Memorandum

SUBJECT: Office of Planning Report for Large Tract Review Case No. 2025-01
4801 Sargent Road NE (corrected)

SUBJECT: Large Tract Review 2025-01 – 4801 Sargent Road NE

Figure 1 | Site Plan

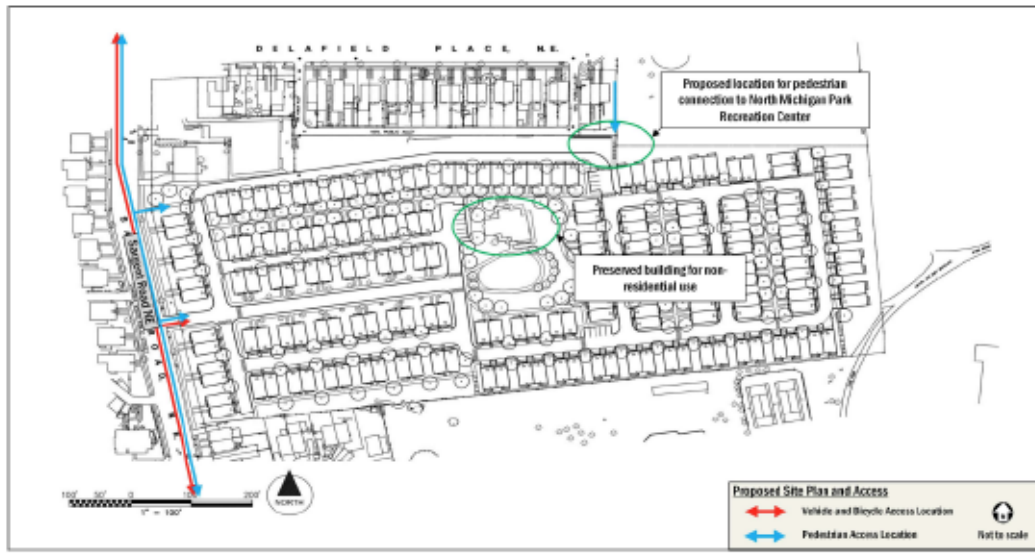
DDOT conducted a thorough review of the Applicant’s LTR application materials, including the site plan in Figure 1 below and the July 2025 Comprehensive Transportation Review (CTR) study prepared by Gorove Slade Associates.

- A network of internal private streets and alleys, available for public use via a public access easement, will connect the houses. Each private street will contain a six-foot sidewalk with buffer, which DDOT strongly supports;

- Although bicycle parking is not required for the residential portion of the development, the Applicant proposes to provide 10 short-term bicycle parking spaces on site for visitors and deliveries to the site, which DDOT supports.
